Access Compliance Report Public Rights-of-Way (Curb Ramps)

Intersection ID: 14910 **Main Street:** LYNDHURST_AV **Cross Street:** IVERSON_WY **Location:** N

ADA ID: 72D86459C92F **Ramp Type:** Perp **Initial Pass/Fail:** Fail **Overall Compliance:** No **Severity Score:** 12.5

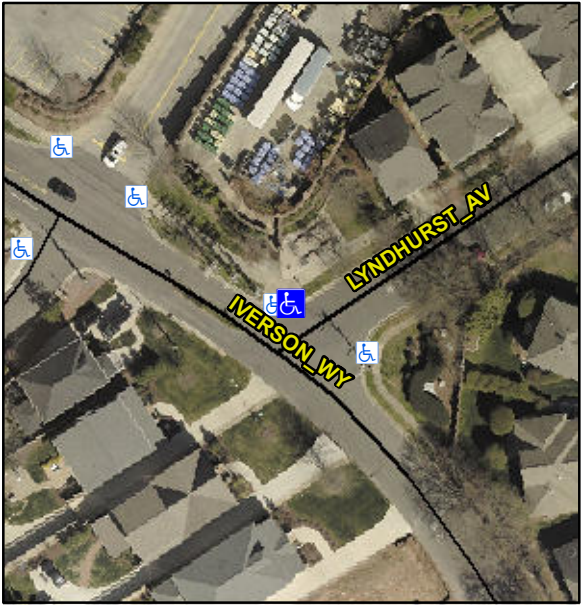
PROW/ADA:
R304.2.2

Compliance	Description	Data	Compliance	Description	Data
N/A	Ramp Length (in)	81.0	No	Ramp Slope (%)	9.1
Yes	Ramp Width (in)	49.0	Yes	Ramp XSlope (%)	1.4
N/A	Flare Type LT	N/A	N/A	Flare Type RT	N/A
N/A	Flare Slope LT (%)	N/A	N/A	Flare Slope RT (%)	N/A
N/A	Flare Traversable LT?	N/A	N/A	Flare Traversable RT?	N/A
N/A	Landing Length (in)	N/A	N/A	DWS Provided?	N/A
N/A	Landing Width (in)	N/A	N/A	DWS Contrast?	N/A
N/A	Landing Slope (%)	N/A	N/A	DWS Length (in)	N/A
N/A	Landing X Slope (%)	N/A	N/A	DWS Full Width?	N/A
N/A	Landing Curb? (Y/N)	N/A	N/A	DWS Offset (in)	N/A
N/A	Shared Landing?	N/A			
N/A	Gutter Ponding?	N/A	N/A	Gutter Slope (%)	N/A
N/A	Gutter Lip Ht (in)	N/A	N/A	Gutter X Slope (%)	N/A
N/A	Painted X Walk1?	No	N/A	Painted X Walk2?	N/A
	X Walk 1 Direction	To SE		X Walk 2 Direction	N/A
N/A	X Walk 1 Width (in)	N/A	N/A	X Walk 2 Width (in)	N/A
	X Walk 1 Slope (%)	2.3		X Walk 2 Slope (%)	N/A
	X Walk 1 X Slope (%)	0.7		X Walk 2 X Slope (%)	N/A

Possible Solutions:
Remove & Replace Entire Ramp.
